MONITORING YEAR 1 ANNUAL REPORT

BIG HARRIS CREEK MITIGATION SITE

RE: Big Harris Creek Mitigation Site – Monitoring Year 1 Report
Final Submittal for DMS
Contract Number 006256, RFP Number 16-006119, DMS# 739
Broad River Basin – CU# 03050105; Cleveland County, NC

Wildlands Engineering, Inc. (Wildlands) has reviewed the Division of Mitigation Services (DMS) comments and observations from the Big Harris Creek Mitigation Site Draft Monitoring Year 1 Report. The following are Wildlands' responses to your comments from the report noted in *italic lettering*.

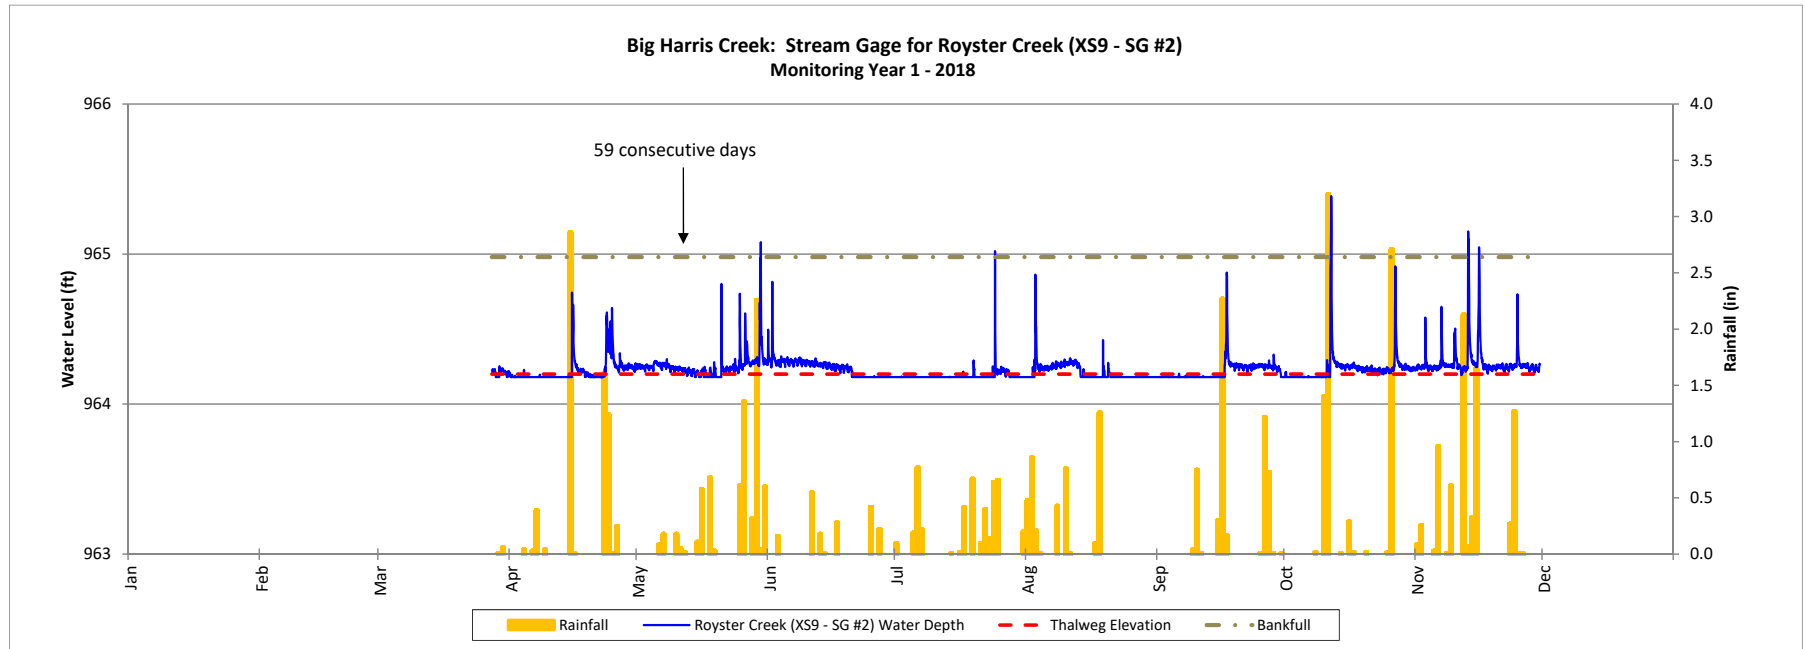
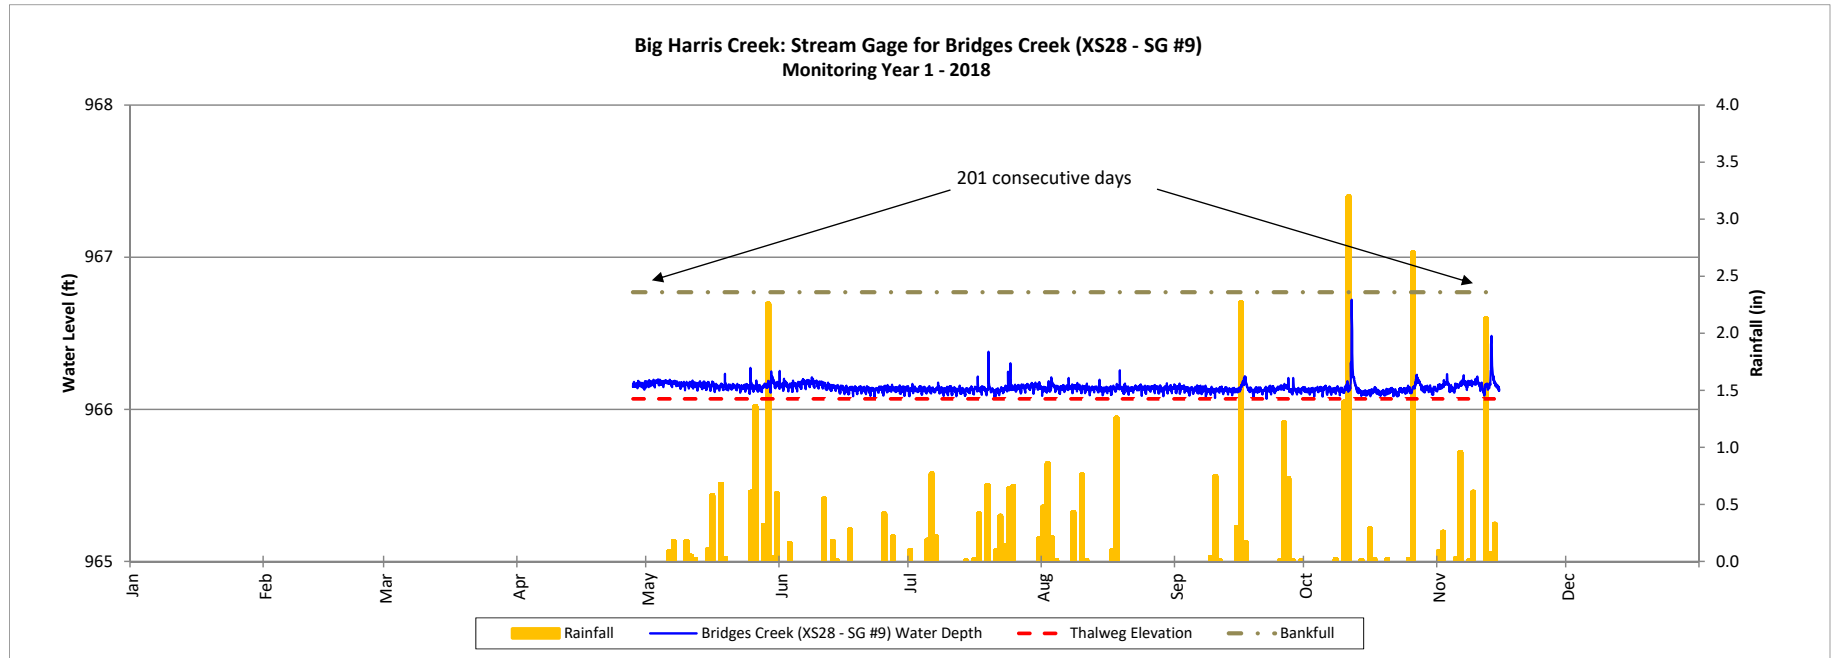
DMS Comment; Appendix 5 – Stream Gage for Royster Creek (XS9 – SG #2) & Stream Gage for Bridges Creek (XS28 – SG#9): Please try to improve the scale of the graphs (if possible). As shown, it is difficult to see the interaction between the water depth and thalweg elevation.

Wildlands Response; The vertical scale was adjusted on the Royster Creek and Bridges Creek stream gage plots to improve clarity between the interaction of the water depth and the thalweg elevation. The rainfall data color was also changed to improve overall clarity.
